SUNDRY NOTICES AND REPORTS ON WELLS

Laura V. Hamner 'A' 1

PLUGGING AND ABANDONMENT PROCEDURE

CONDITIONS OF APPROVAL

WELLBORE DIAGRAM

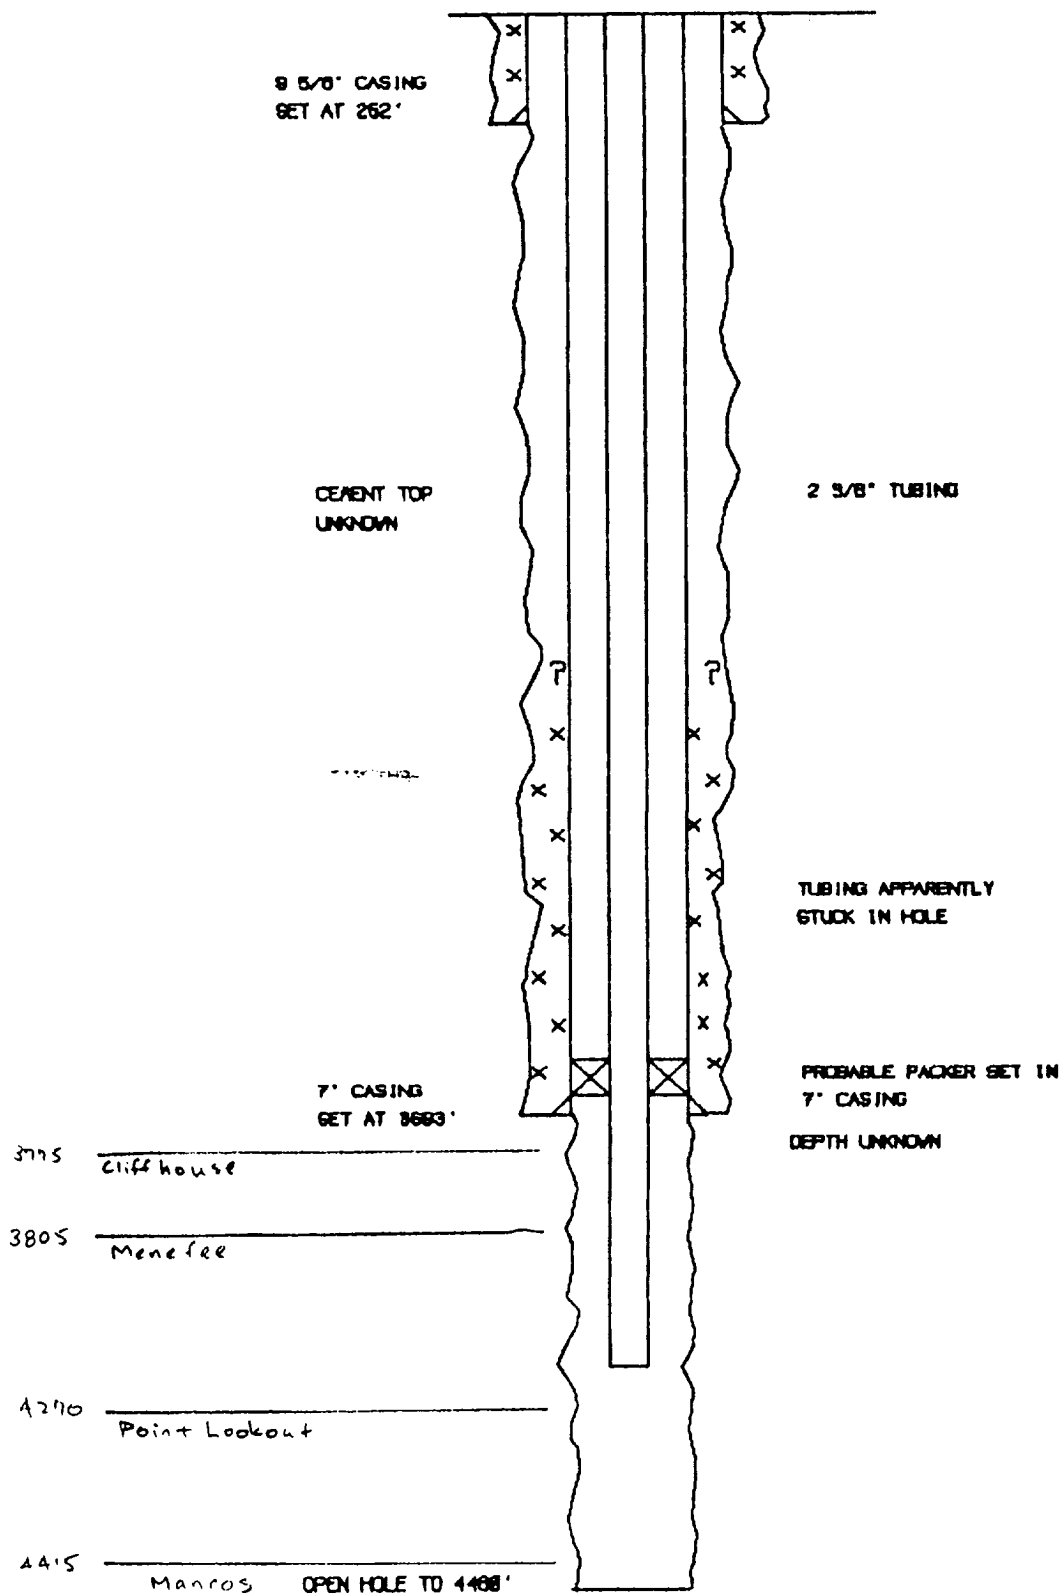
4. The following modifications to your plugging program are to be made (when applicable):

After squeezing the Mesaverde Formation under a retainer and leaving 50' cement on top of retainer, proceed with the following as a minimum:

1) From CBL Log, if possible, perforate @ 2735' and place a plug from 2735' to 2635' plus 100% excess inside & outside of casing. (Chart Top - 2685')

* 2) Perforate @ 2125' and place a plug from 2125' to 2025' plus 100% excess, inside & outside of csg. (P.C. Top - 2075')

* 3) Perforate @ 1840' and place a plug from 1840' to 1740' plus 100% excess, inside & outside of csg. (Fruitland top - 1790')

* Note! PC & Fruitland plugs can be combined. Perf. @ 2125' and place a plug from 2125' to 1740' plus 100% excess.

4) Perforate @ 1145' and place a plug from 1145' to 880' plus 100% excess, inside & outside of csg. (C&A line 930' - 1095')

5) Perforate @ 302' and circulate cement to surface
